**ANGEL PLACE
LEVEL 8, 123 PITT STREET
SYDNEY NSW 2000**

SECTION 4.55 (1A) MODIFICATION - TARONGA ZOO UPPER AUSTRALIA PRECINCT – SSD-10456 - HERITAGE IMPACT STATEMENT LETTER

This letter has been prepared by Urbs on behalf of Taronga Conservation Society Australia (**TSCA** – the ‘Proponent’) in support of a Section 4.55(1A) application to modify the original State Significant Development (**SSD**) Application SSD-10456 relating to the Upper Australia Precinct of Taronga Zoo.

Figure 1 – Tree Protection and removal plan
 Source: Lahznimmo Architects, November 2021

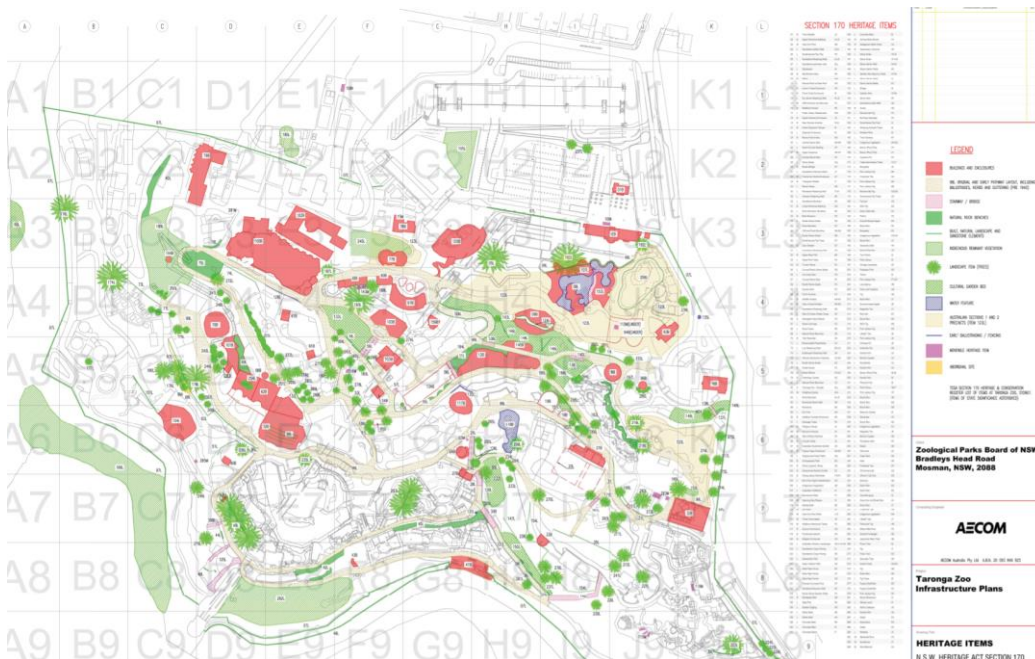
Eleven locally endemic trees are to be removed as they are damaged or will have major encroachments into their Structural Root Zones (**SRZ**). The trees to be removed include:

- Tree 123 *Eucalyptus botryiodes* (Bangalay) – this tree is subject to removal as it failed during an extreme weather event.
- Tree 129 *Melaleuca quinquenervia* (Broad-leaved Paperbark) and Tree 130 *Casuarina cunninghamiana* (River She-oak). The proposed development will cut into the SRZ of these two trees. Tree 130 also has a substantial lean over the proposed path hence, these trees are to be removed.

- Tree 156 and Tree 157 *Eucalyptus botryiodes* (Bangalay) – the proposal will encroach on their TPZ and SRZ.
- Tree 162 *Casuarina Cunninghamiana* – The proposal will encroach on the TPZ and SRZ.

- Tree 179 *Lophostemon Confertus* – The proposal will encroach on the TPZ and SRZ.
- Tree 185 *Lophostemon Confertus* – The proposal will encroach on the TPZ and SRZ.

Trees to be replaced on the broader Taronga Zoo site to reflect but will not be located within the Upper Australia Precinct to ensure no impacts on the bushfire risk.
